H12260

## DESCRIPTIVE REPORT

*General Locality* Krenitzin Islands

## Revisions and Corrections performed during office processing and certification.

**1.2) Profile/Beam - 1288/200 from sheet\_a04 / 3-d2 / 2010-178 / 3a04-sh106****DANGER TO NAVIGATION****Survey Summary**

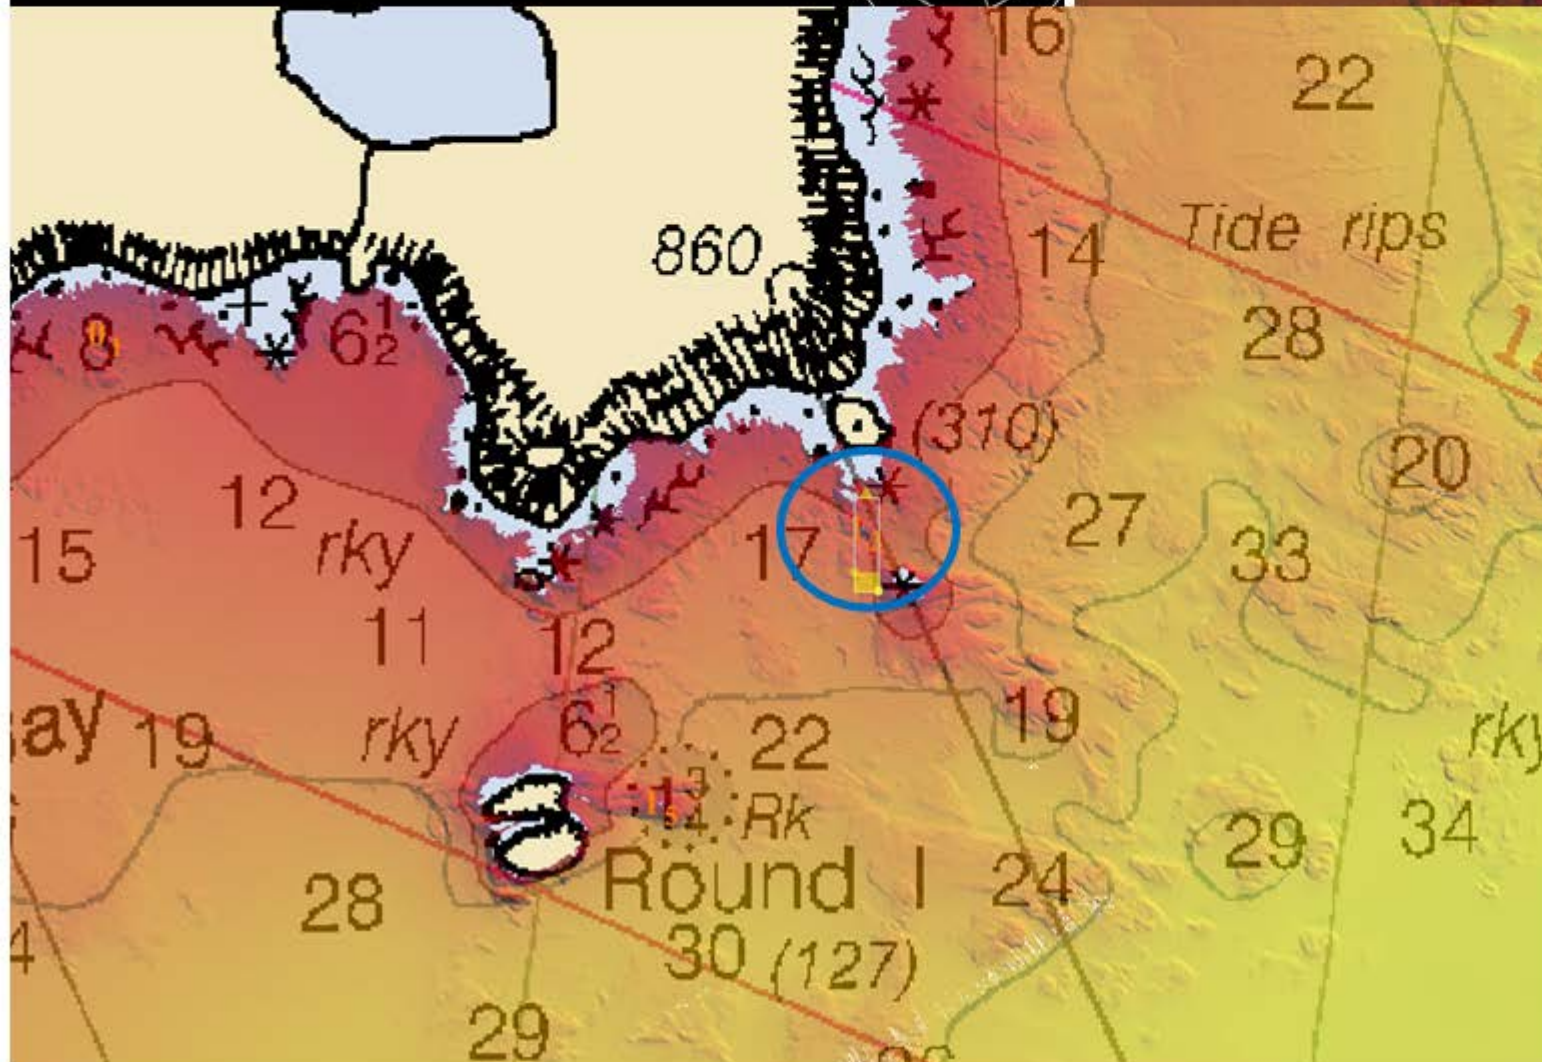
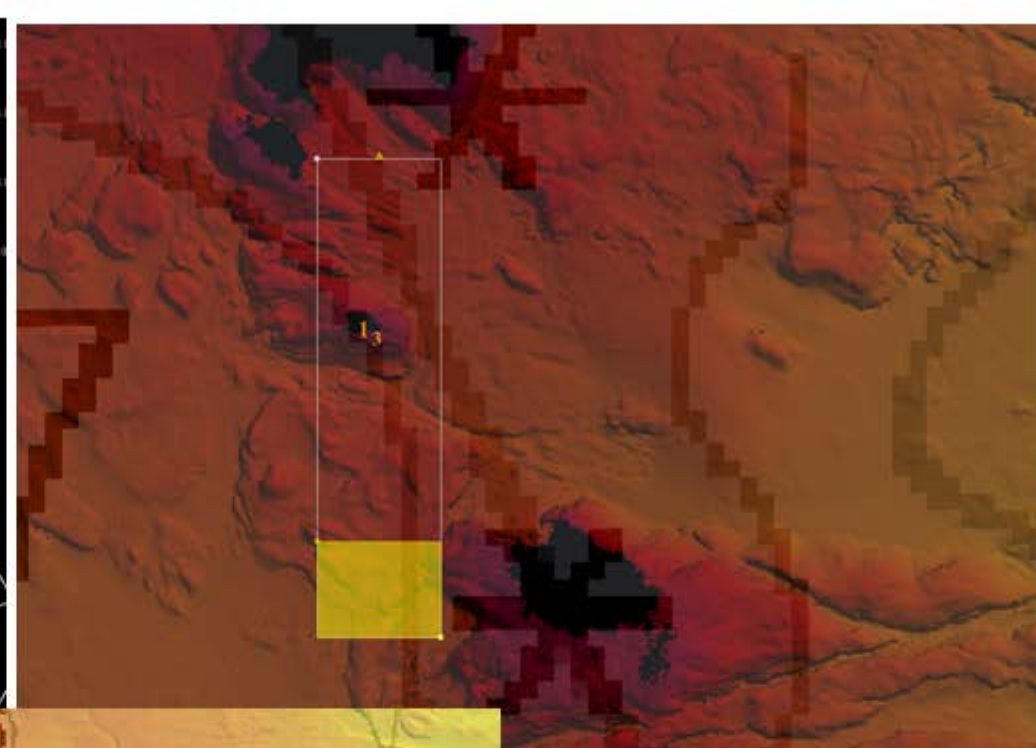
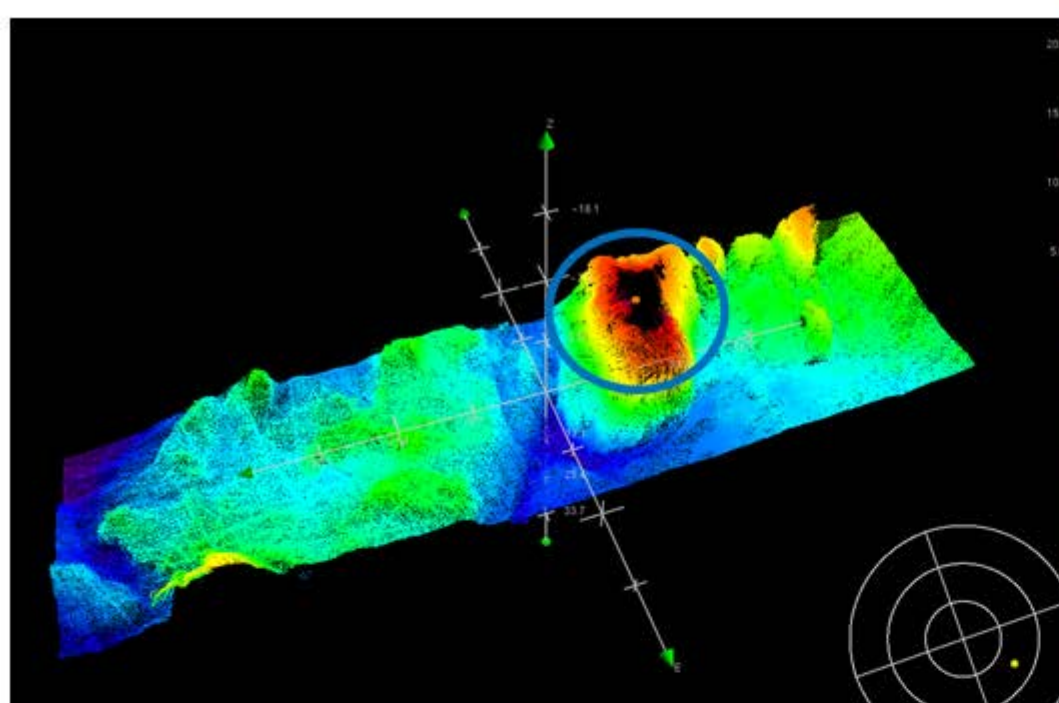
uncharted underwater rock, depth unknown, least depth 1fm 3ft.

chart as DTON

DTON #1.2 was not applied to the chart by MCD;

It was compiled to the chart update product as a 1 fm 3 ft submerged rock.

### 1.3) Profile/Beam - 622/208 from sheet\_a04 / 3-d2 / 2010-178 / 3a04-sh107

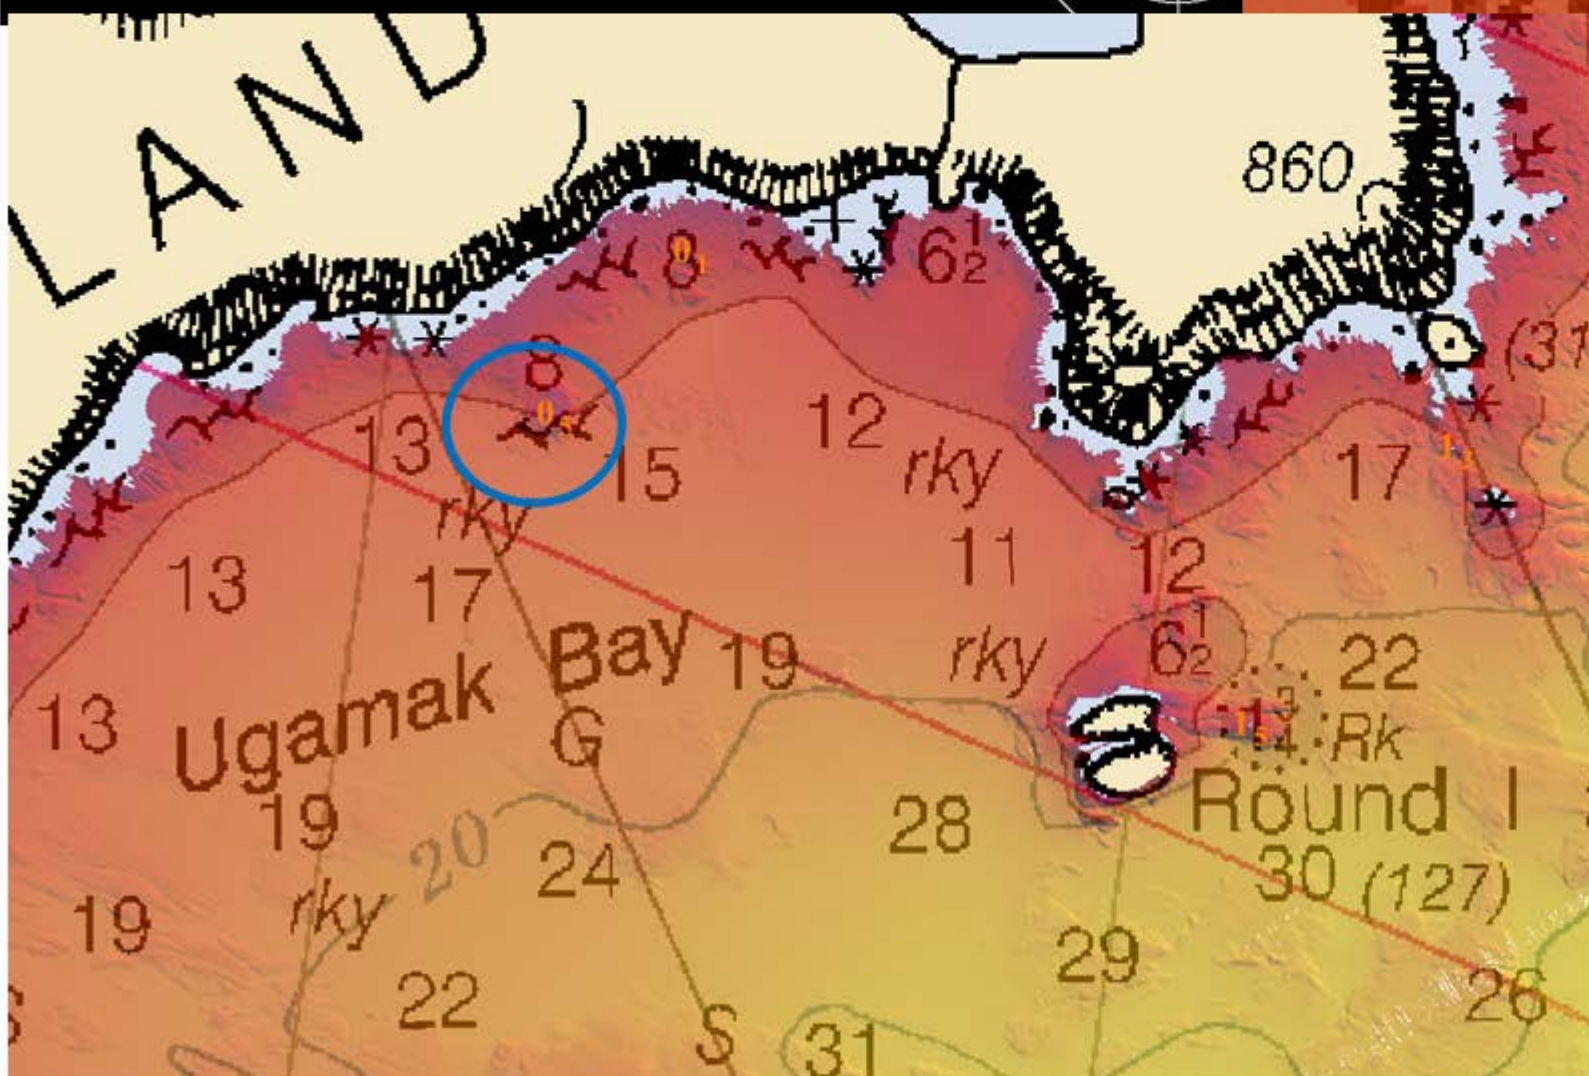
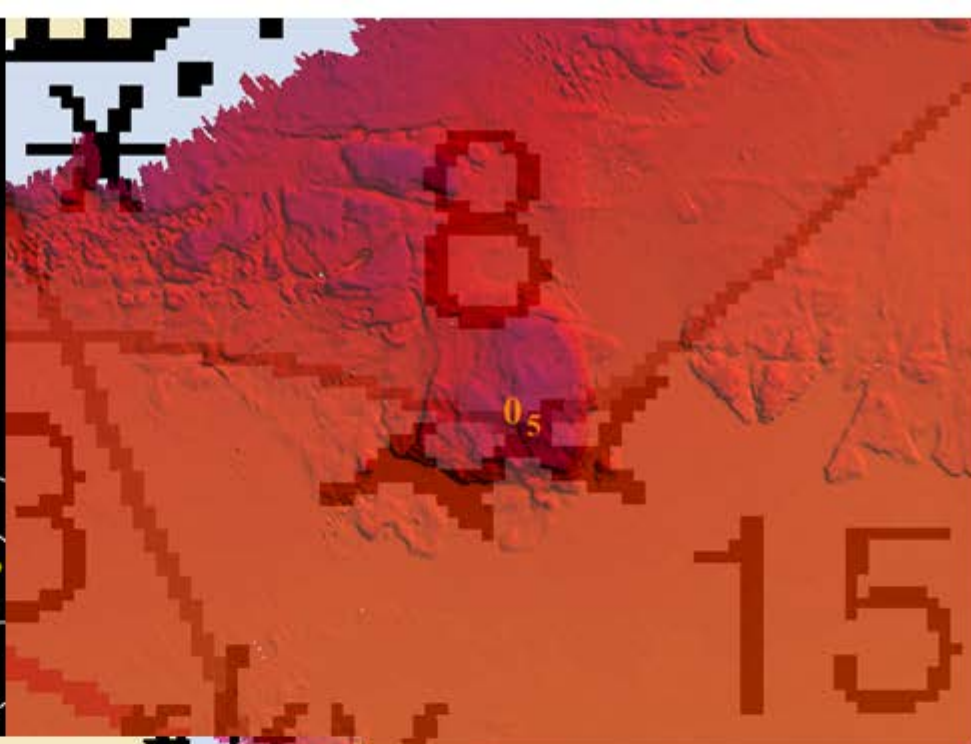
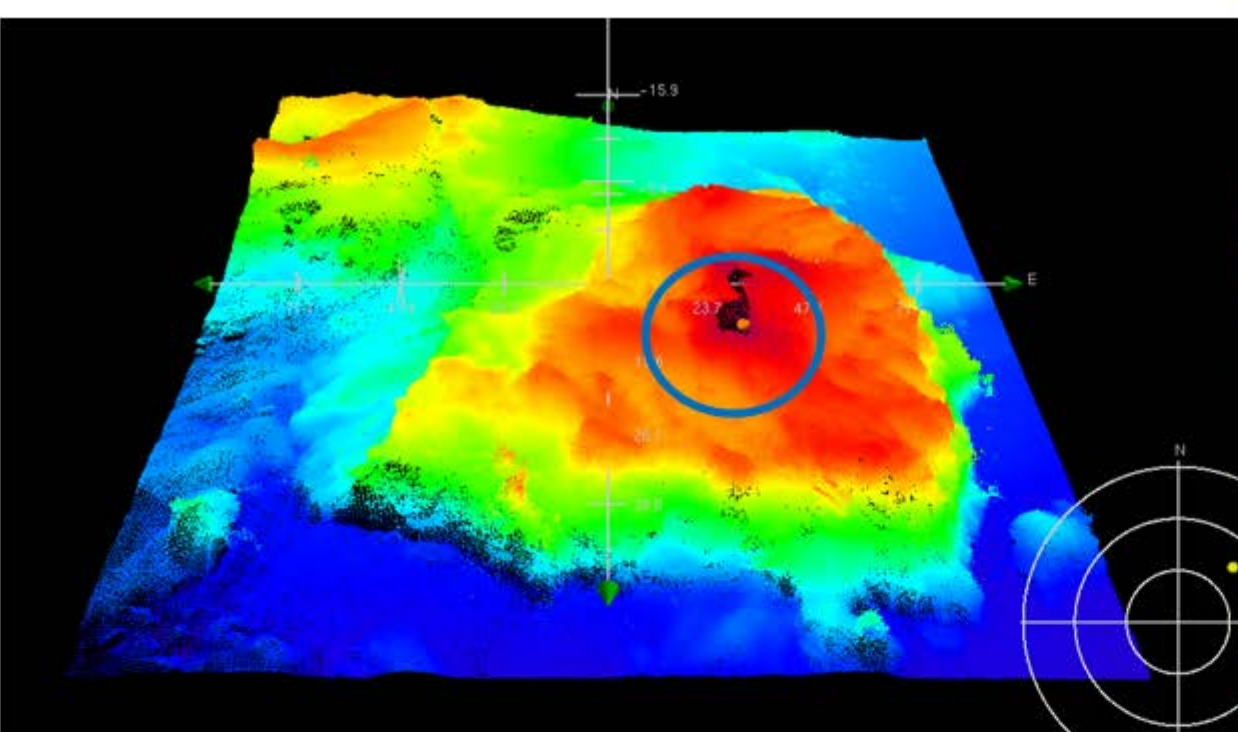
330m SSE of mid-Ugamak Bay, 0fm 5ft sdg on the 10fm contour line.

chart as DTON

DTON #1.3 was applied to the chart by MCD as a 1 fm shoal;

It was compiled to the chart update product as a 0 fm 5 ft submerged rock.

## 1.4) Profile/Beam - 1217/454 from sheet\_a04 / 3-d2 / 2010-186 / 3a04-sh231

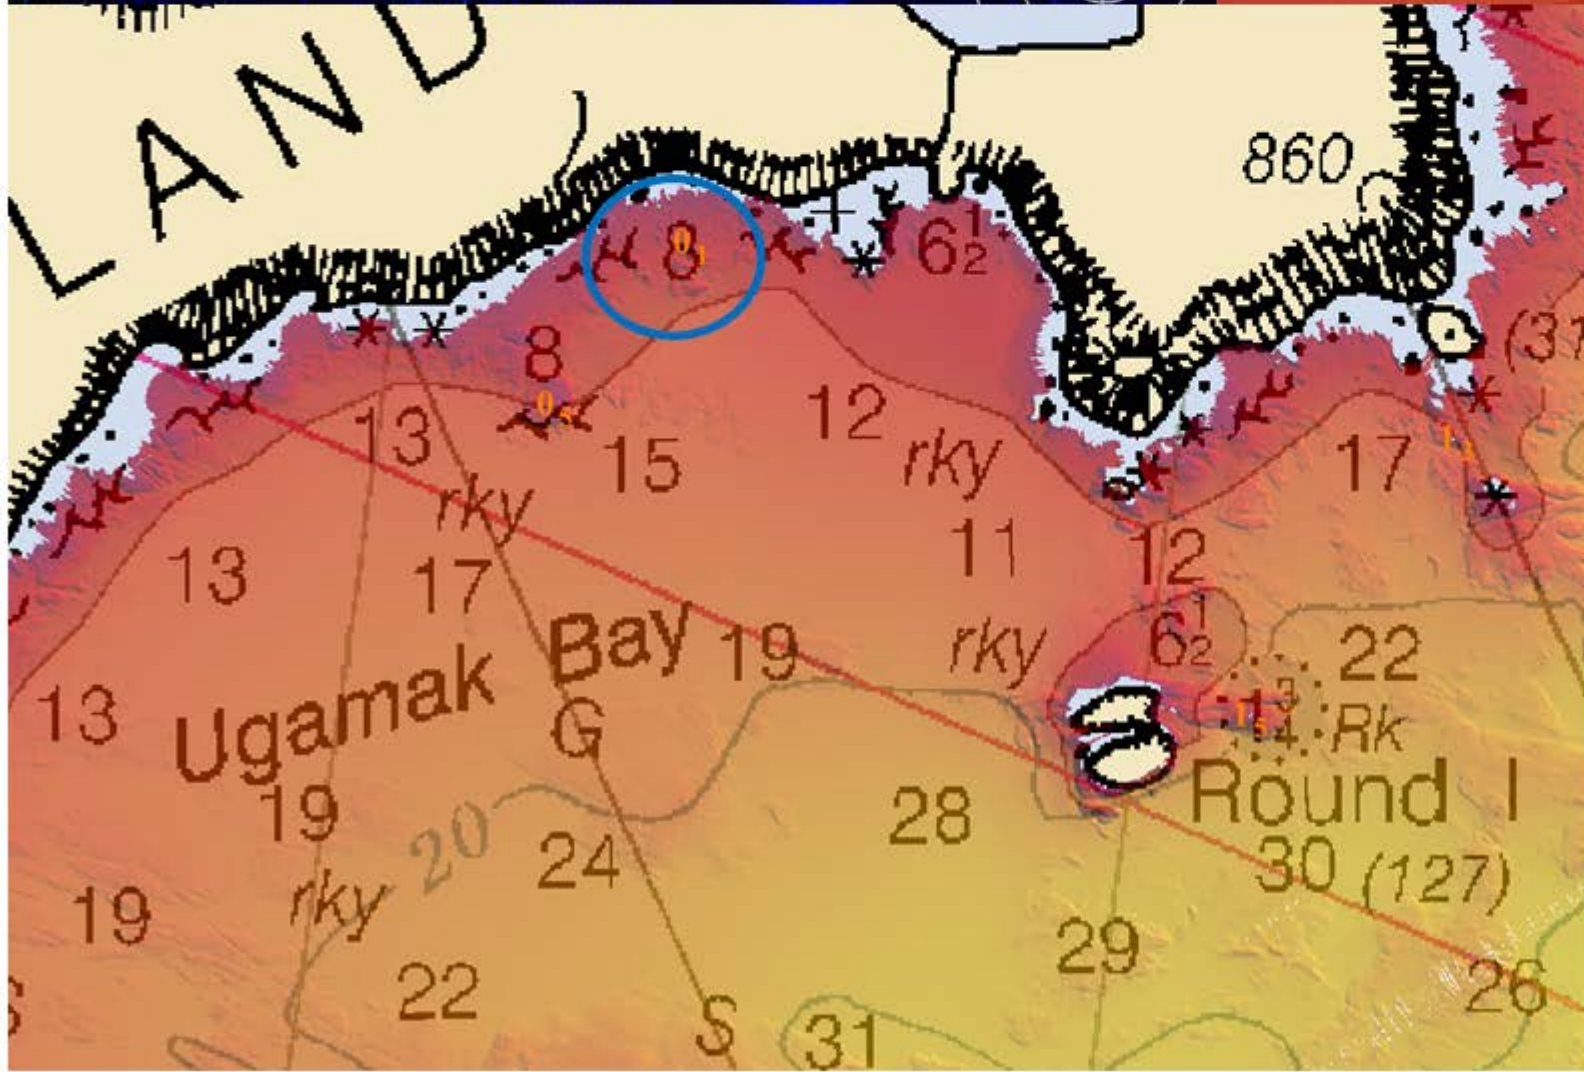
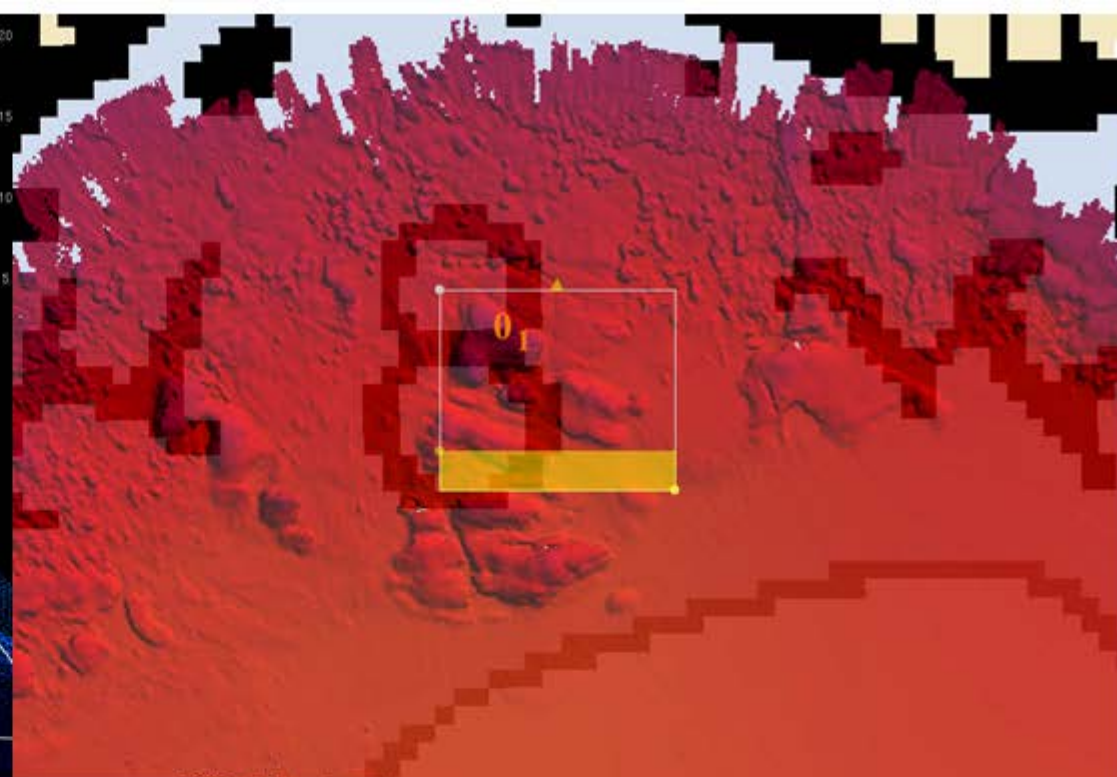
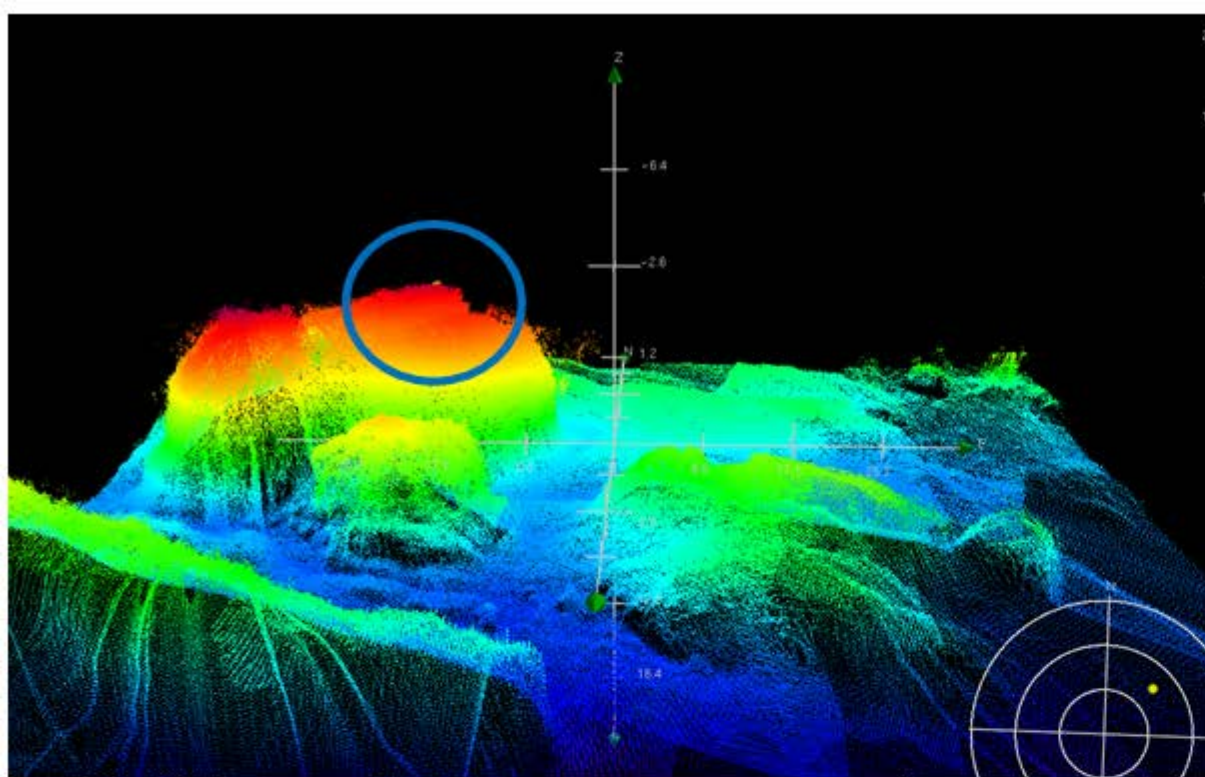
175m S of northern Ugamak Bay, 0fm 1ft sdg uncharted underwater rock.

chart as DTON

DTON #1.4 was not applied to the chart by MCD;

It was compiled to the chart update product as a 0 fm 1 ft rock awash.
